Split Solitary Island—Amendments to charts with regard to reef north-westward of.

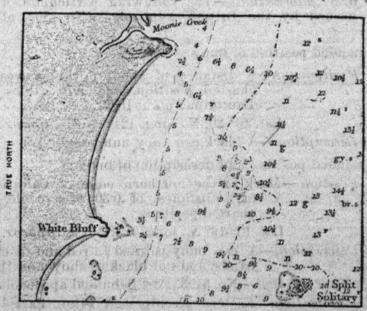
Details.—Amendments to the charts with regard to the reef northwestward of Split Solitary island, consequent upon a recent examination of the vicinity, are shown on the accompanying reproduction of a portion of chart No. 1026.

Charts affected .- No. 3401, Halsey harbour.

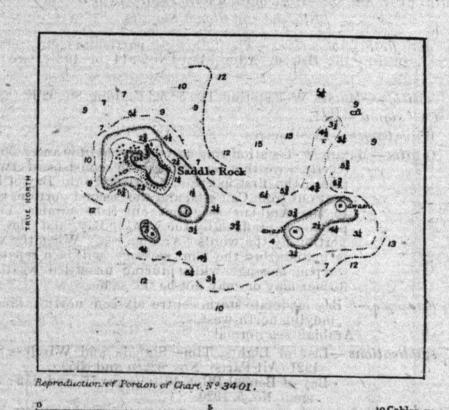
Details.—The accompanying reproduction of a portion of chart No. 3401 shows the necessary corrections to that chart with regard to the shoal eastward of Saddle rock.

Split Solitary Island-Amendments to charts with regard to reef north-westward of.

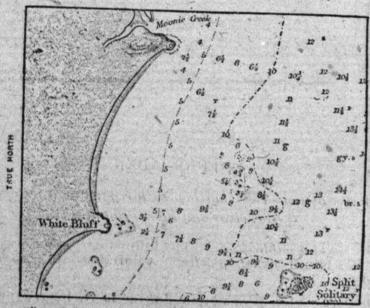
Details.—Amendments to the charts with regard to the reef north-westward of Split Solitary island, consequent upon a recent examination of the vicinity, are shown on the accompanying reproduction of a portion of chart No. 1026.

Charts affected .- No. 3401, Halsey harbour.

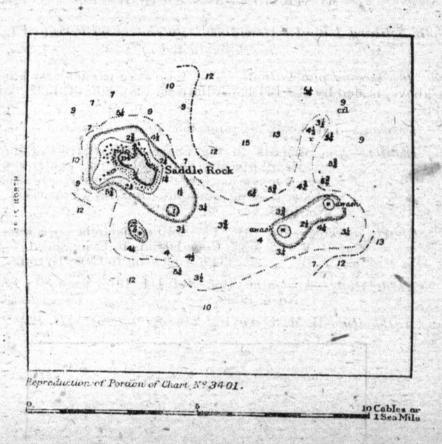
Details.—The accompanying reproduction of a portion of chart No. 3401 shows the necessary corrections to that chart with regard to the shoal eastward of Saddle rock.

Charts affected.—No. 1026, The Solitary islands and adjacent coast.
,, 1027, Coffs islands to Evans head.

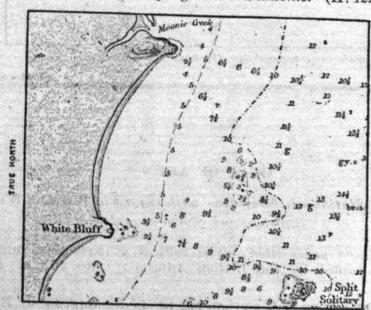
Details.—Amendments to the charts with regard to the reef northwestward of Split Solitary island, consequent upon a recent examination of the vicinity, are shown on the accompanying reproduction of a portion of chart No. 1026.

Charts affected .- No. 3401, Halsey harbour.

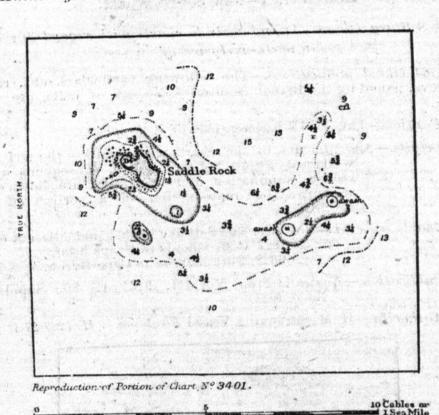
Details.—The accompanying reproduction of a portion of chart No. 3401 shows the necessary corrections to that chart with regard to the shoal eastward of Saddle rock.

Charts affected.—No. 1884. Arakan river, with plan.
" 1369, Mayu river to Kyank Pyu harbour.
Publication.—Bay of Bengal Pilot, 1910, pages 341, 342.
Authority.—Director, Royal Indian Marine. (H. 1814-21.)

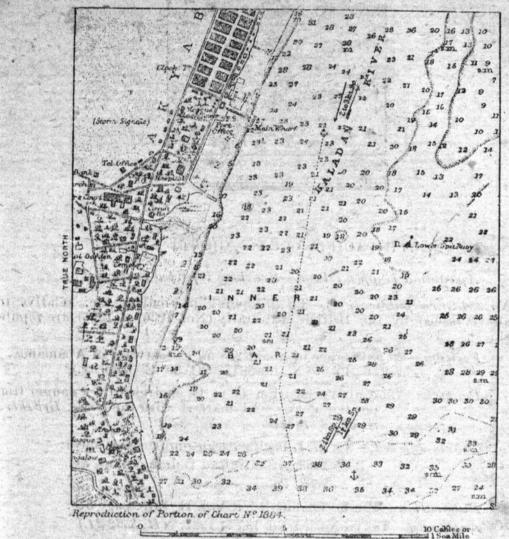
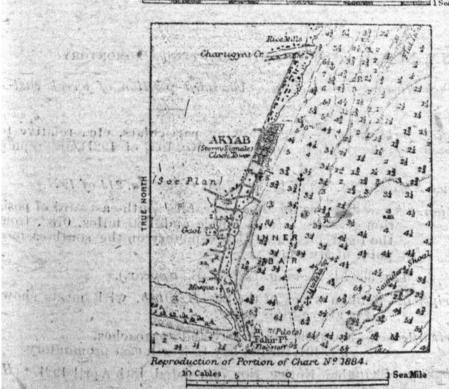
Details.—Amendments to the charts with regard to depths on the inner bar and vicinity, consequent upon a recent survey, are shown on the accompanying reproductions of portions of charts Nos. 1884 and 1369.

From the reproductions it will be observed that a general decrease in depths has taken place; the survey, as shown, revealed a least depth of 20 feet (6 m 1) on the inner bar April 1921.

> Chart affected.-No. 1999, Ports Lyttelton and Levy, and Pigeon bay, with plan.

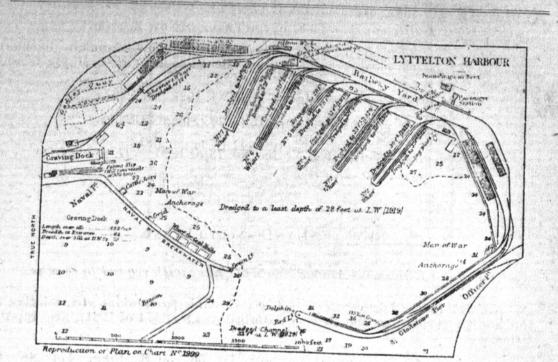
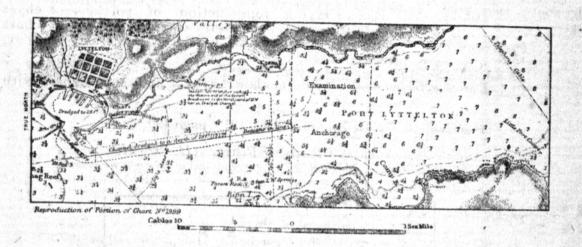
> Details.—The accompanying reproductions of portions of chart No. 1999, show the necessary corrections to that chart with regard to the depths in Lyttelton-harbour and the entrance channel.

> Remarks.—It will be observed that extensions have been made to Nos. 5 and 6 wharves, and that two buoys have been established near the harbour entrance.

Reproduction of Portion of Chart Nº3720

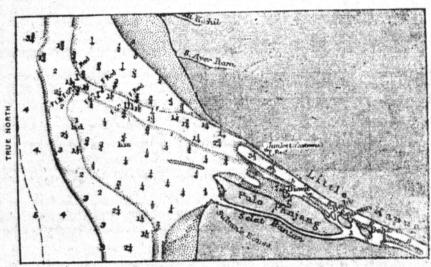
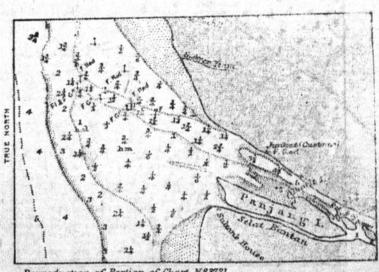
Details.—The accompanying reproduction of portions of charts Nos. 3720 and 3721 shows the necessary corrections to those charts with regard to depths, &c., in the entrance to Little Kapuas river, together with the amended posi-tion of the fixed red light at Junkat.

Reproduction of Portions of plan on Chart Nº 684.

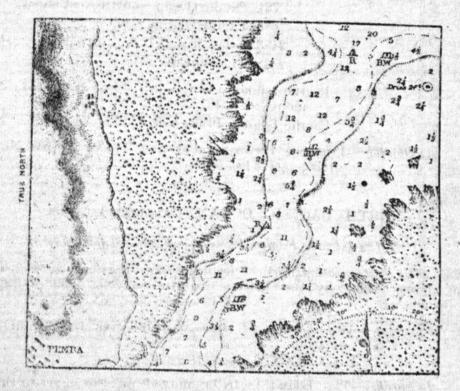
Details.—The accompanying reproduction of two portions of the plan of Mikindani harbour entrance on chart No. 684 shows the necessary corrections to that plan with regard to have accompanying

Charts affected.-No. 2265, Kobe and Hyogo bays.

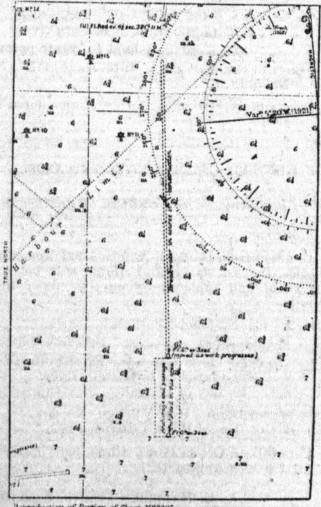
Details.—The accompanying reproduction of a portion of chart No. 2265 shows the projected limits of a detached breakwater in course of construction together with an area which is marked by light-buoys and within which anchorage and passage are prohibited; the prohibited area will be extended, and the northern light-buoy moved, as the work advances.

Charts affected .- No. 1884. Arakan river, with plan. " 1369, Mayu river to Kyank Pyu harbour. Publication.—Bay of Bengal Pilot, 1910, pages 341, 342. Authority.-Director, Royal Indian Marine. (H. 1814-21.)

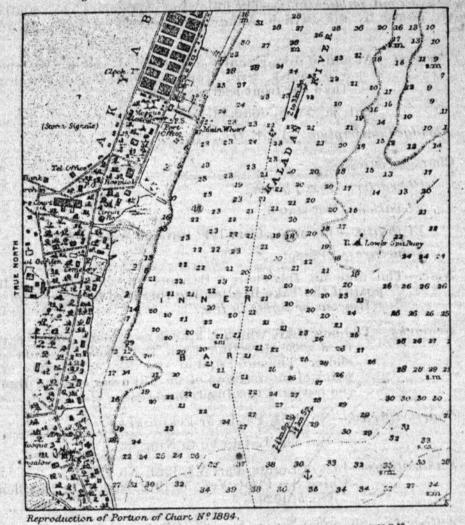
Details.—Amendments to the charts with regard to depths on the inner bar and vicinity, consequent upon a recent survey, are shown on the accompanying reproductions of portions of charts Nos. 1884 and 1369.

Charts affected.-No. 3732, Penang harbour.

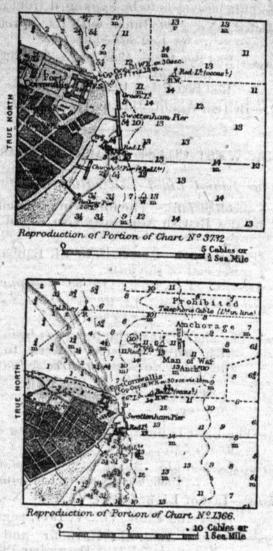
Details.—The accompanying reproduction of portions of charts Nos. 3732 and 1366 shows the necessary corrections to those charts with regard to Swettenham pier, the positions of the pier lights, and the alteration in position of the buoys in the vicinity of the pier.

Charts affected.—No. 1070, Port Stephens.

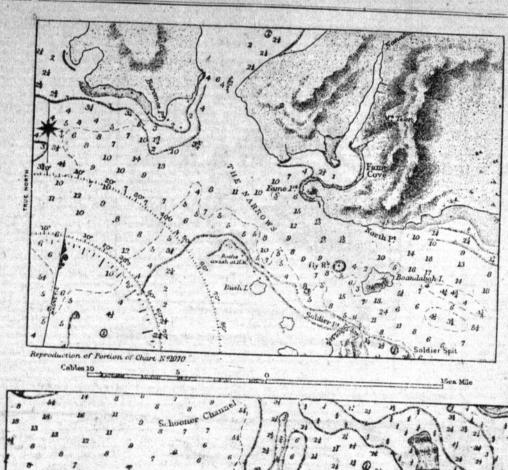
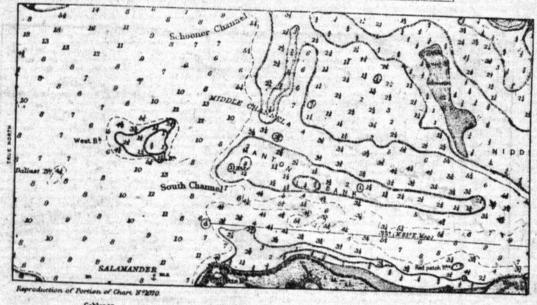
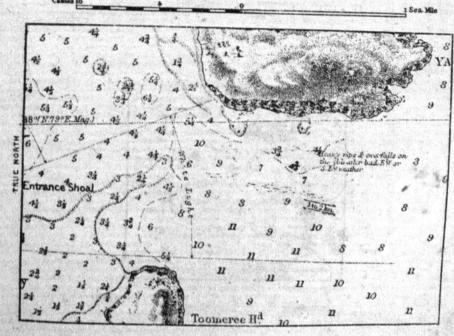
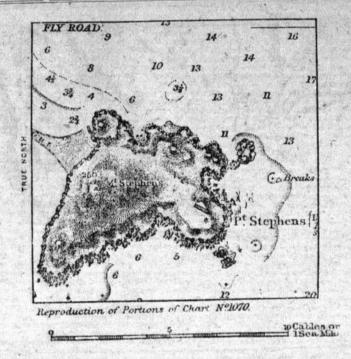
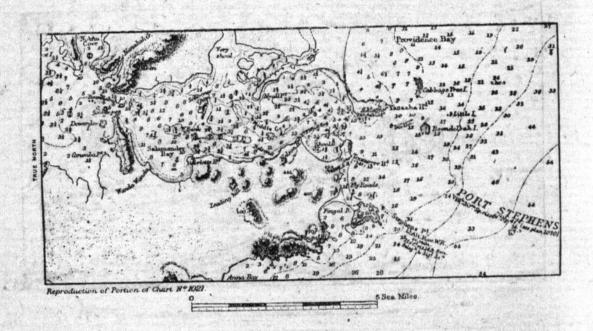
Details.—The accompanying reproductions of portions of charts Nos. 1070, 1021, 1024 and 3622 show the necessary corrections to those charts with regard to shoals, as revealed by a recent survey.

The following cautionary note is to be inserted on chart No. 1070 :-

A recent survey shows the existence of a number of additional dangers outside the main channel; this chart must therefore be used with caution.

Chart affected .- No. 1999, Ports Lyttelton and Levy, and Pigeon bay, with plan.

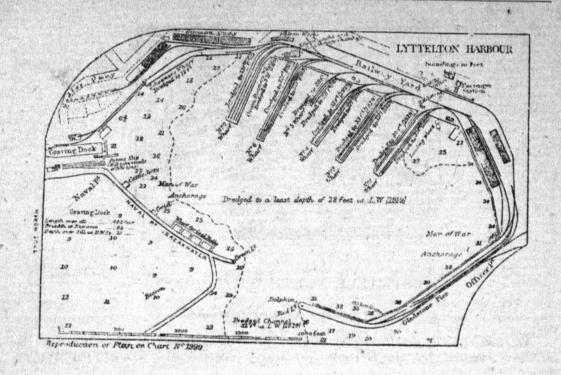
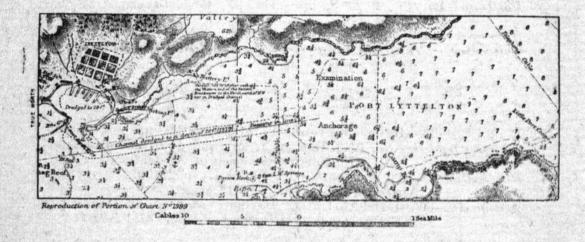
Details.—The accompanying reproductions of portions of chart No. 1999, show the necessary corrections to that chart with regard to the depths in Lyttelton harbour and the entrance channel.

> Chart affected.-No. 1970, Auckland harbour and approaches, with plan.

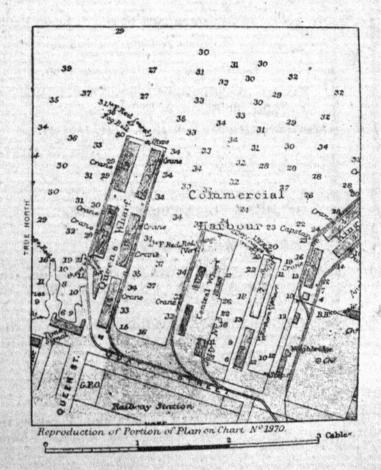
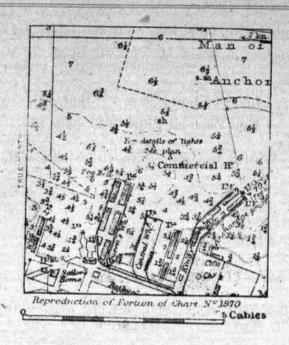
> Details.—The accompanying reproduction of portions of chart No. 1970 shows the necessary corrections to that chart with regard to depths in the Commercial harbour, Auckland.

Charls affected .- No. 2747, Entrance to Port Phillip.

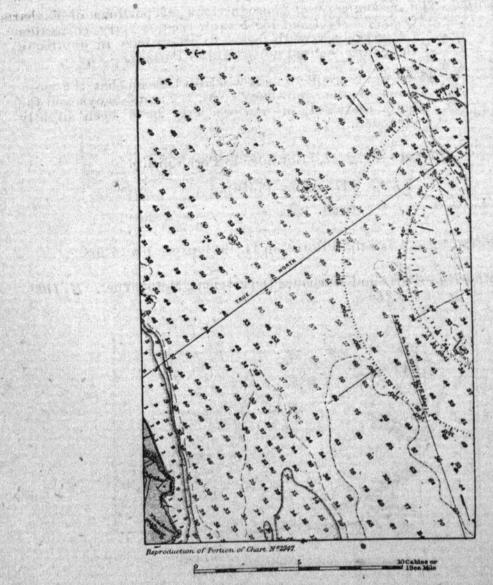
Details.—The accompanying reproductions of portions of charts Nos. 2747, 1171 and 1695b show the necessary correction to those charts with regard to alterations in depths in the South channel northward of Portsea.

Charts affected.—No. 3720, Pontianak to Tanjong Bayung. " 3721, Masa Tiga island to Pontianak.

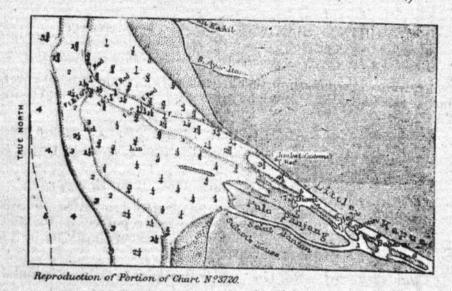
Details.—The accompanying reproduction of portions of charts Nos. 3720 and 3721 shows the necessary corrections to those charts with regard to depths, &c., in the entrance to Little Kapuas river, together with the amended position of the fixed red light at Junkat.

Charts affected .- No. 967, Palawan island.

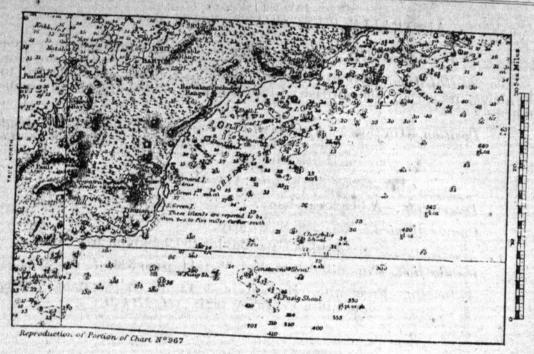
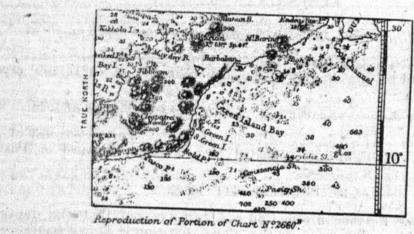
> Details.—The accompanying reproductions of portions of charts Nos. 967, 2660b, 943, 2578 and 1263 show the necessary corrections to those charts with regard to reefs and shoals between Deep bay and Dumaran island.

Charts affected.—No. 1969, Ozuchi jima to Funoko sima.

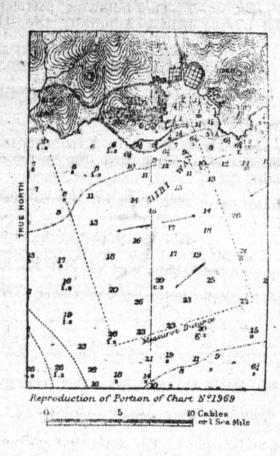
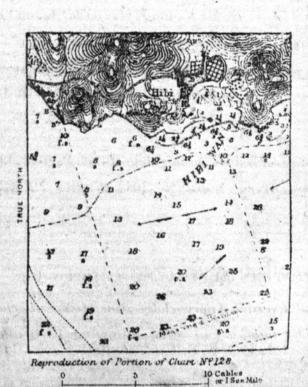
Details.—The harbour works at Hibi wan have now been completed and a measured distance, indicated by beacons, has been established as shown on the accompanying reproduction of portions of charts Nos. 1969 and 128.
